SITE PLAN

for : MJ Builders
CLIENT

12355 Falcon Ridge Road — Chesterland
ADDRESS — STREET — CITY

LOT — TRACT — TOWNSHIP: Kirtland — OHIO

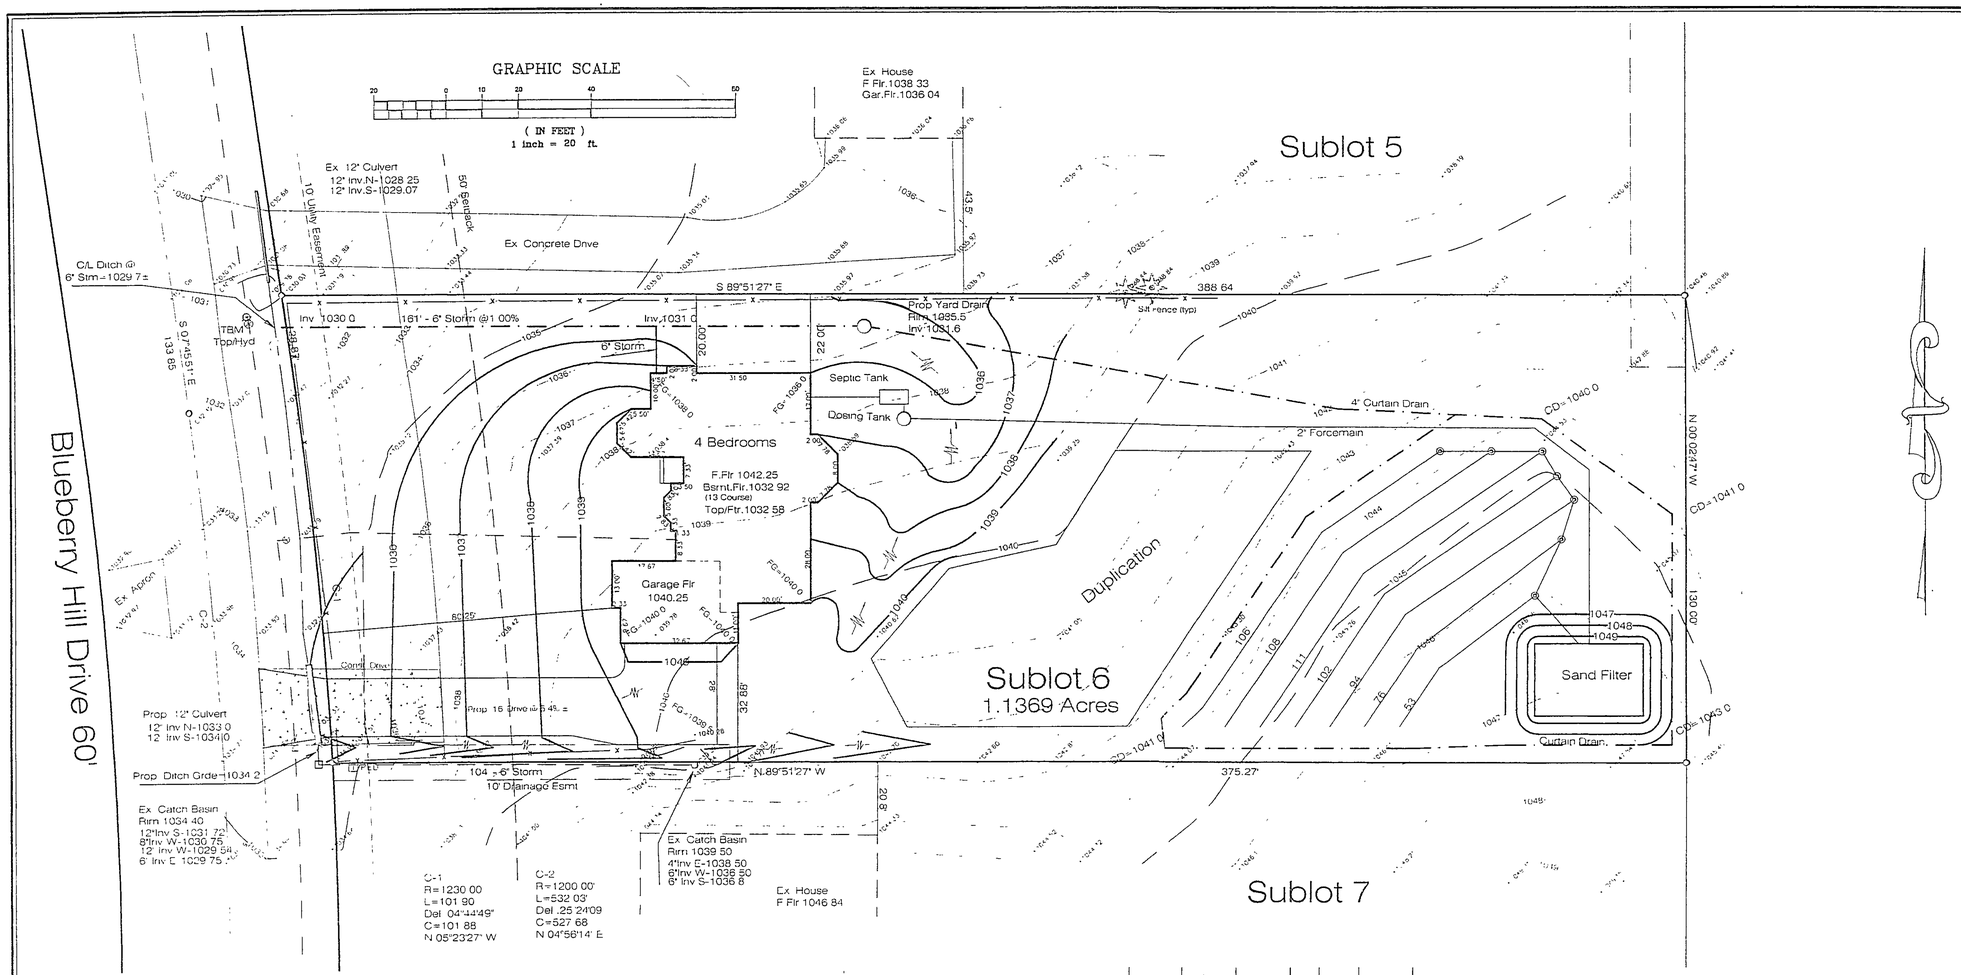
① ROOF DRAINS TO BE CONNECTED TO STD. SEWER
② PROVIDE SWALE ALONG NORTH PROP. LINE
③ DRIVEWAY CULVERT SHOULD BE LOWERED TO ATTAIN MORE COVER. REGRADE EXIST DITCH ALONG THE R/W.
